# Addressing the Proposed Overshoot Modification

- Comments #248, #249, #250 and #251

802.3dj interim

May 2026 Munich Germany

CI 180 SC 180.7.1 P468 L38 # [REDACTED]

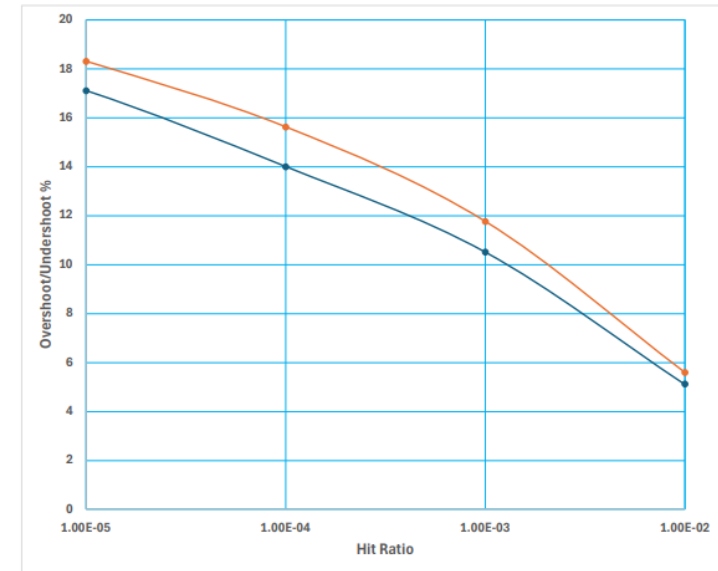
In D2.0 1T DFE was added to the TDECQ equalizer where DFE is superior to improve TDECQ for bandlimited transmitters over using large overshoot/undershoot which can have 1-2 dB of SNR penalty given TDECQ doesn't incorporate peak-to-average penalty. Overshoot/undershoot of 22% at 1E-2 hit ratio can also result in clipping and frame loss.

Hit ratio of 1E-2 has no merits given SSPRQ and Ethernet scrambled data. Peak-peak amplitude for example are measured at hit ratio of 1E-7 in DJ. Change hit ratio from 1E-2 to 1E-4 and reduce overshoot/undershoot from 22% to 18% given that TDECQ has DFE no longer such high overshoots are necessary. see [ghiasi\\_3dj\\_02\\_2605](#)

# Overshoot/Undershoot Results

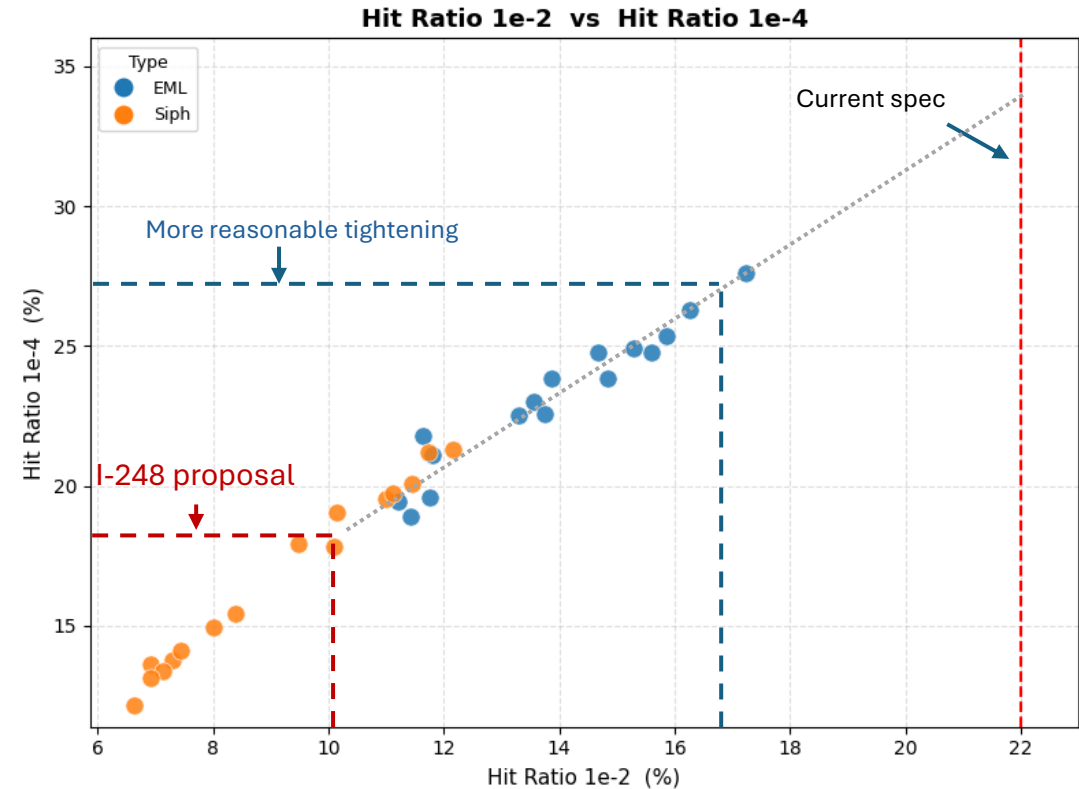
- The proposed tightening represents roughly a 55% reduction from the current overshoot specification.
- Such a reduction would have a significant impact on existing Tx implementations and therefore requires strong technical justification.
- While changing the hit ratio from  $1e-2$  to  $1e-4$  may improve the robustness of the specification, it should be paired with a corresponding adjustment to the allowable spec limit.
- Proposal: Adopting a hit ratio of  $1e-4$  with a spec limit of 27% would remain achievable with current designs, while also addressing concerns about potential 50% overshoot claims noted in [ghiasi\\_3dj\\_01a\\_2603](#)

- I-248 proposes an aggressive change that could impact current implementations without sufficient data to demonstrate that it is technically necessary.
- A more balanced approach would be to set the overshoot limit to 27% at a  $1e-4$  hit ratio.
- Alternatively, the current specification should be maintained until a more comprehensive analysis is completed to justify the change.
